AGENDA
FARRAGUT MUNICIPAL PLANNING COMMISSION

April 20, 2017
7:00 p.m. Farragut Town Hall

**SUBJECT: STAFF COMMENTS ON THE REVISED SITE PLAN FOR THE
DOLLAR GENERAL, 12403 KINGSTON PIKE**

Drawing Title:
TEACHING CENTER -
EXTERIOR ELEVATIONS

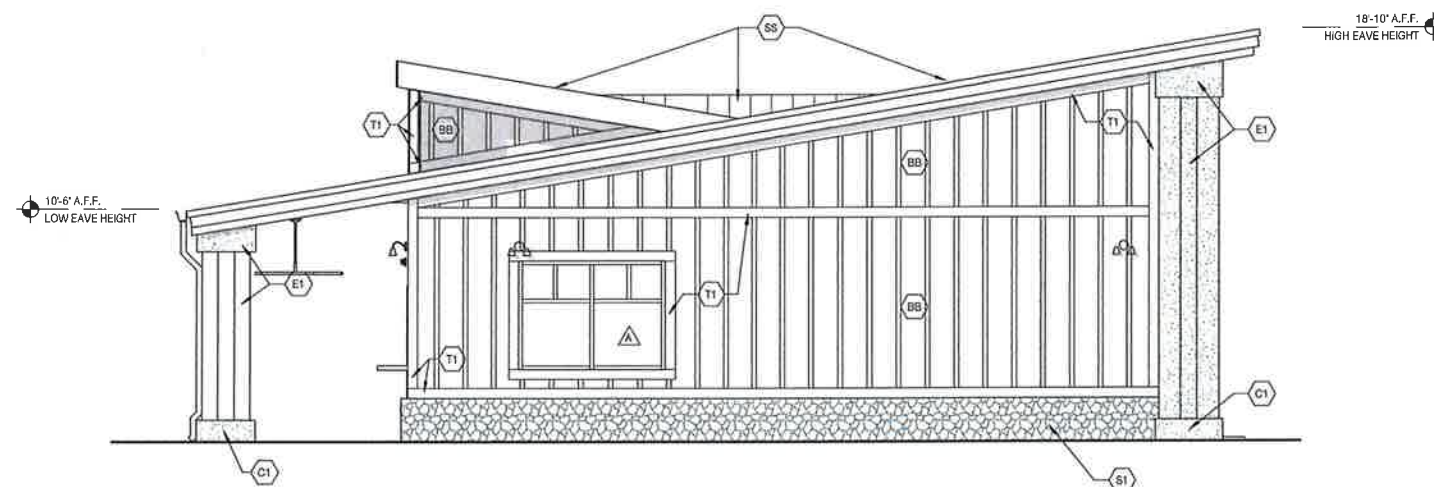
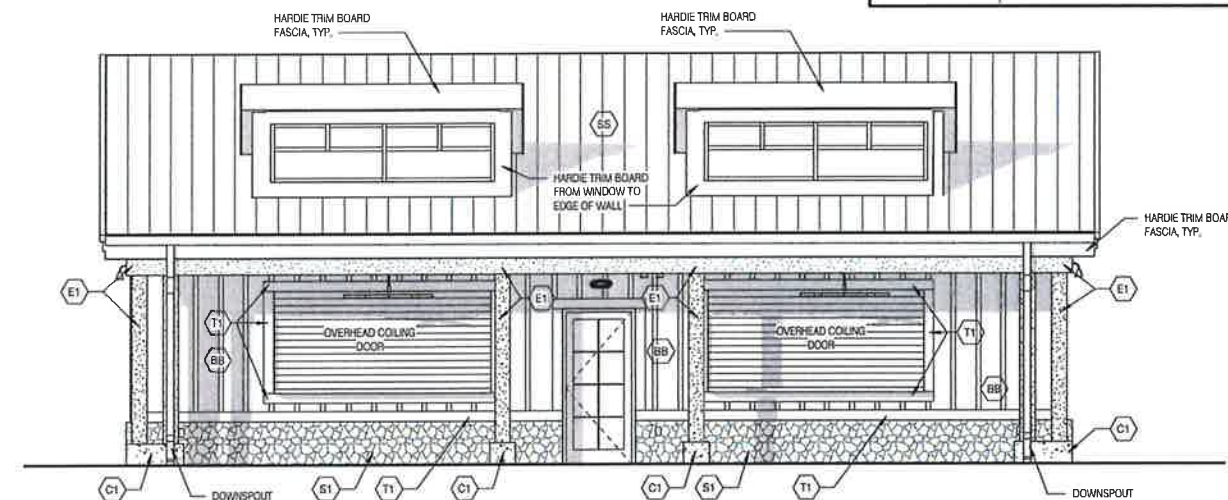
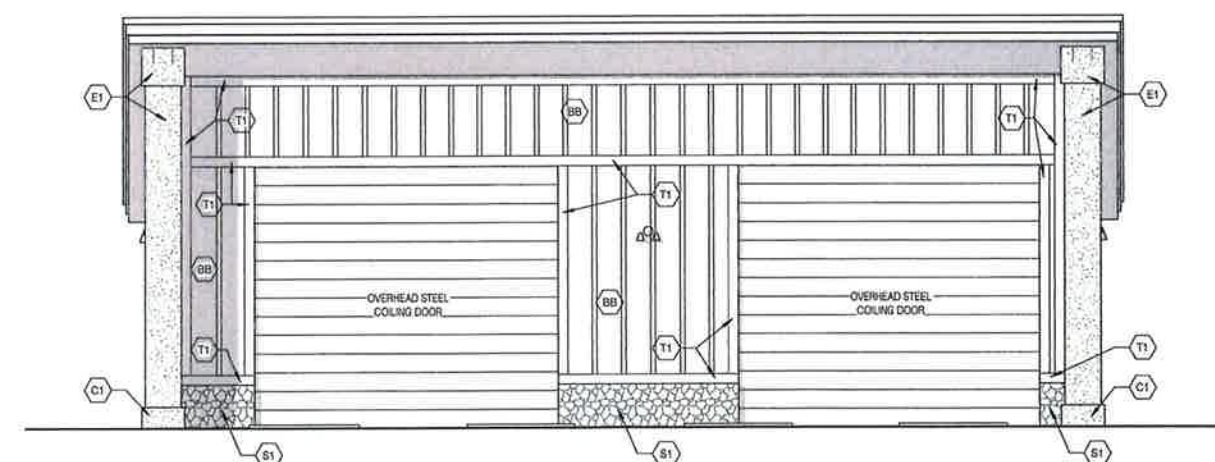
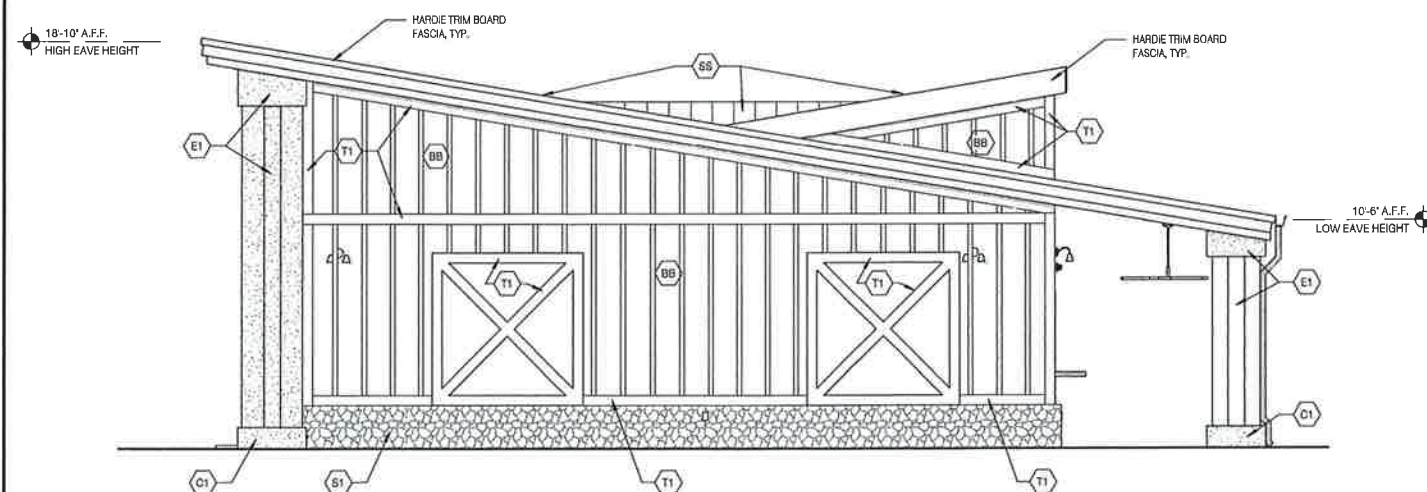
DISCUSSION: The applicant has revised the size and appearance of the training center building. The previously approved building was 925 square feet and included a predominantly masonry (stone) exterior. The proposed training center building is roughly 1,400 square feet and includes a predominantly hardie board siding. Though the square footage increase is not of a real concern from the staffs' perspective, the proposed change in exterior materials warrants some discussion.

A question is whether the amended request by the applicant is consistent with this language. In making such a determination, consideration should be given to the context and whether this type of material on an accessory building would be appropriate in other portions of the Town. The proposed training center building would be over 370 feet from the nearest property line and there are some homes in the nearby area that do have hardie board siding. In addition some portions of other buildings on the clubhouse property appear to have a type of hardie board siding.
